| Title - Sujet Mechanical System Upgrade for North Modernisation du système mécanique des ailes nord et sud | |
| Solicitation No. - N° de l'invitation EZ899-222066/A | Amendment No. - N° modif. 002 |

This Amendment 002 is raised to issue Addendum 001.

- .1 Ships Ladder Crossover Sample Drawing (provided by contractor for information only. Not for construction)
.2 Roof Barrier Sample Drawing (provided by contractor for information only. Not for construction)

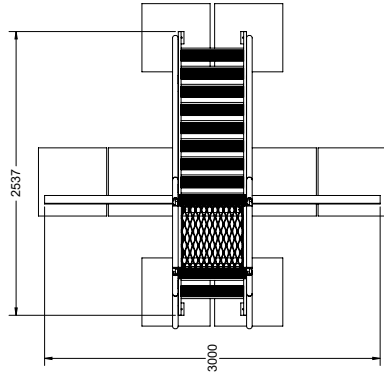
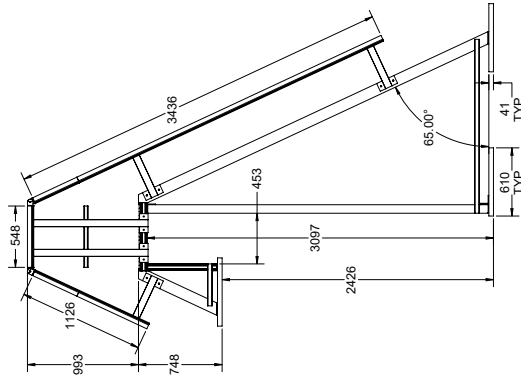
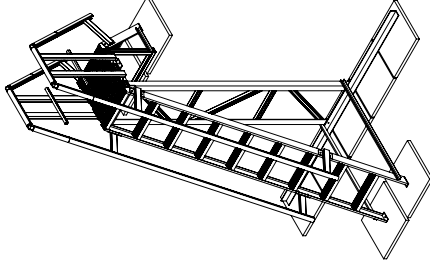
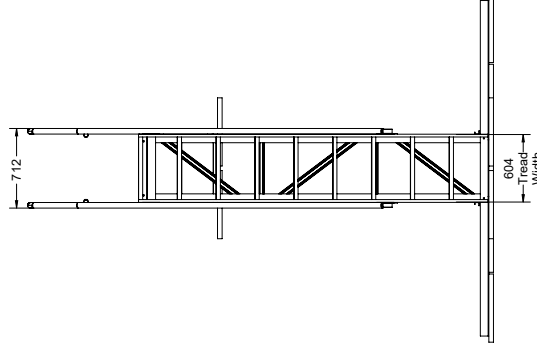
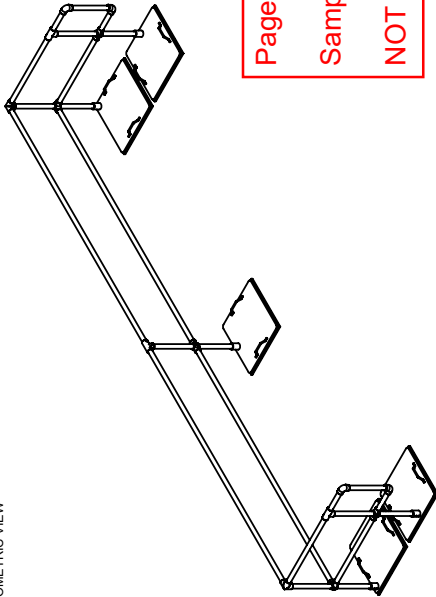
- .1 Q.: Request for approval of the following products:
- a. Modular aluminum ships ladder
 - i. The system comes in modular components and is assembled on site

- ii. It can be designed to be non-penetrating/ballasted, reducing cost of install and eliminating any structural tie-ins
 - iii. It is aluminum – will not rust over time, and is more light-weight so is more cost effective to install

- iv. We provide site specific shop drawings 1 week from an order being placed
 - v. We have material in stock, and fabricate in max 4 weeks from signed approved drawings

Response: Above proposed systems appear to be:

- a. architecturally acceptable provided that complete information including but not limited to size of handrail, guardrail diameter, base plate size, attachment to the roof, etc. in a proper shop drawing are provided; and
- b. structurally acceptable, as long as it will be designed and shop drawings sealed by a structural engineer (P.Eng.) registered in BC.

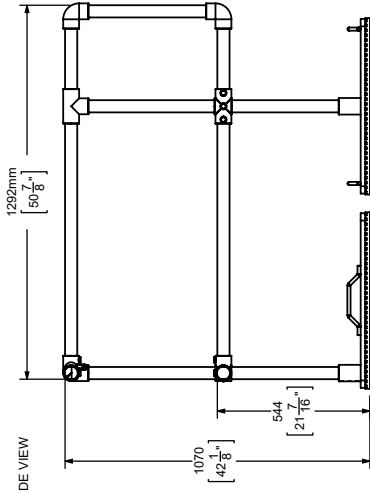
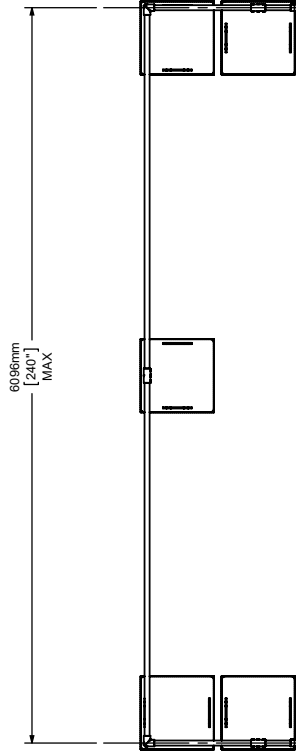
- b. 5001 series modular Roof Barrier guardrail
 - i. The system is ballasted/non-penetrating
 - ii. It is pre-engineered and pre-manufactured, equalling a faster lead time and simpler installation

- iii. It comes with the posts pre-assembled equalling 50% time savings on install
 - iv. We provide site specific shop drawings 2-3 days from an order being placed

- v. We have it in stock and would ship 2-3 days from signed approved drawings
 - c. sample drawings of both systems are attached.
